**CALIFORNIA COASTAL COMMISSION**

December 8, 2005

**RE: Comments on Draft Environmental Impact Statement/Environmental Impact Report  
("EIS/EIR") for the Long Beach LNG Import Project**

**FERC Docket No. CP04-58-000, et al./POLB Application No, HDP 03-079**

Figure 6 POLB Proposed SES Long Beach LNG Facility Fatality FN Curves

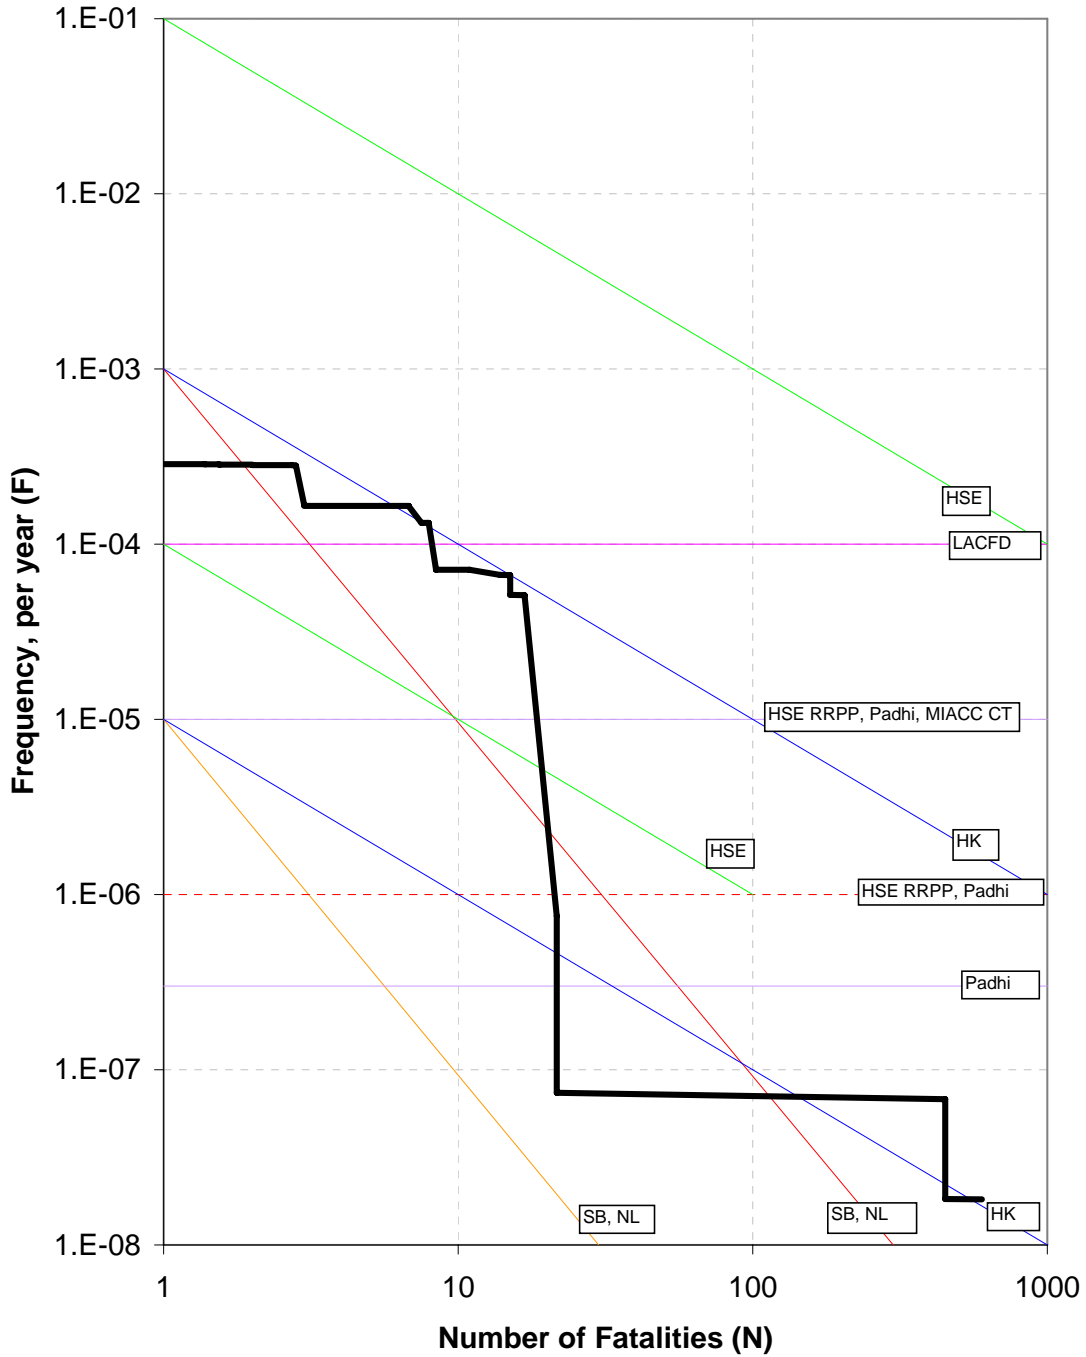
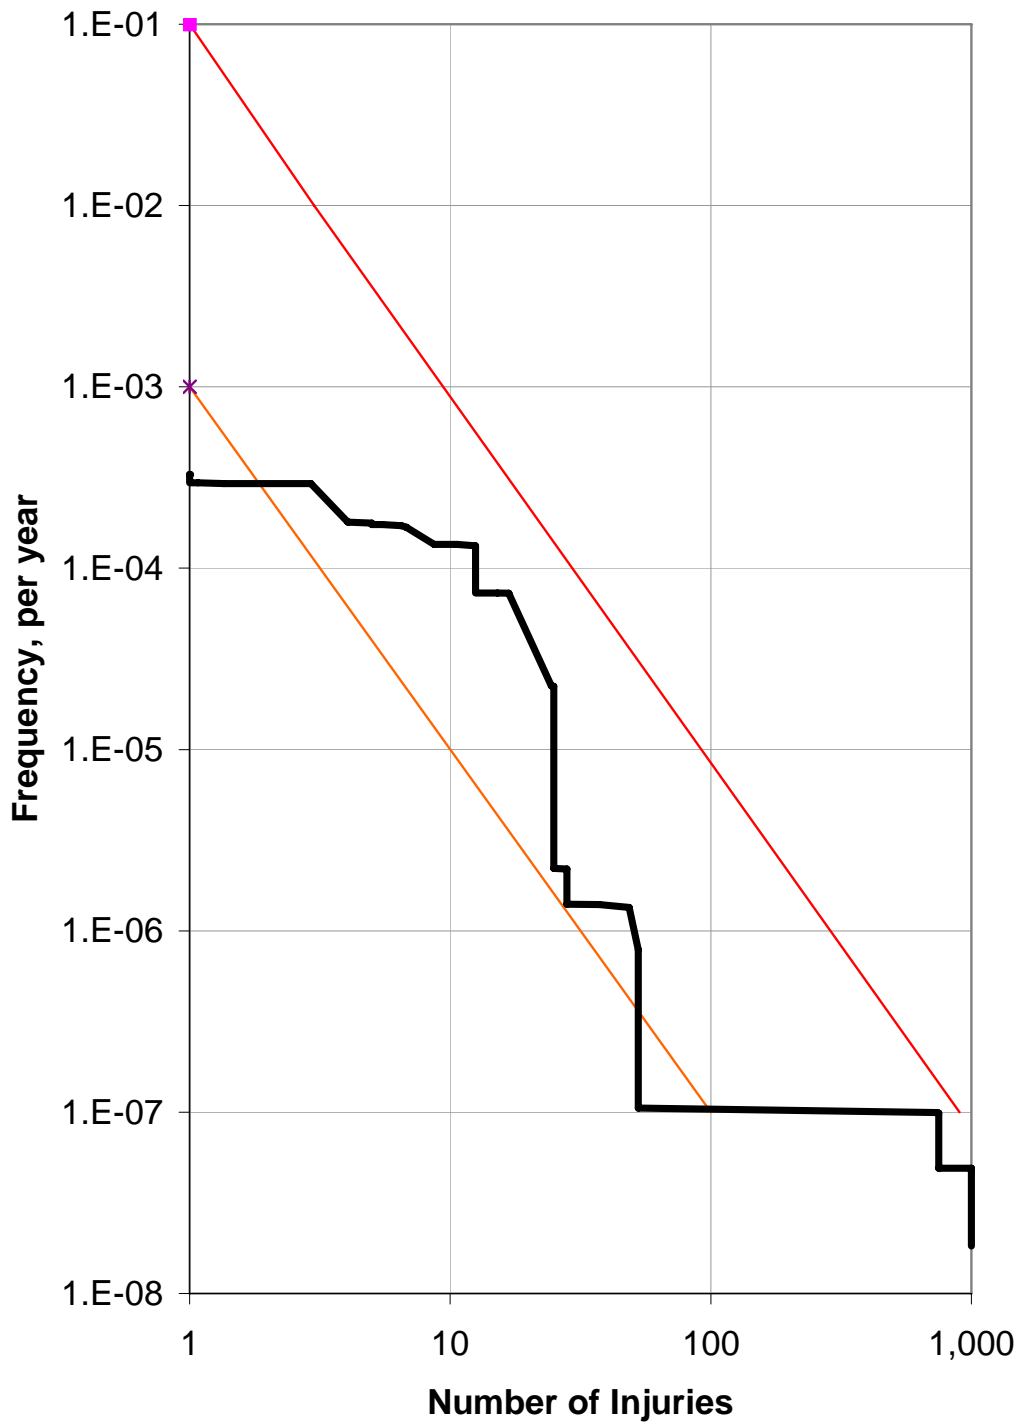
Figures 6 and 7 in Attachment A (pages 29-30) provide the results of the QRA in terms of societal risk. The FN curve is compared to a range of acceptability criteria, most specifically the criteria developed in the Netherlands and adopted by Santa Barbara County. In virtually all cases, the societal risk associated with the project would be considered intolerable in the absence of additional safety mitigation. To provide a more thorough analysis of project risk, including the evaluation of the risk associated with all credible events, the FERC and the Port should incorporate the results of the QRA in a revised EIS/EIR.
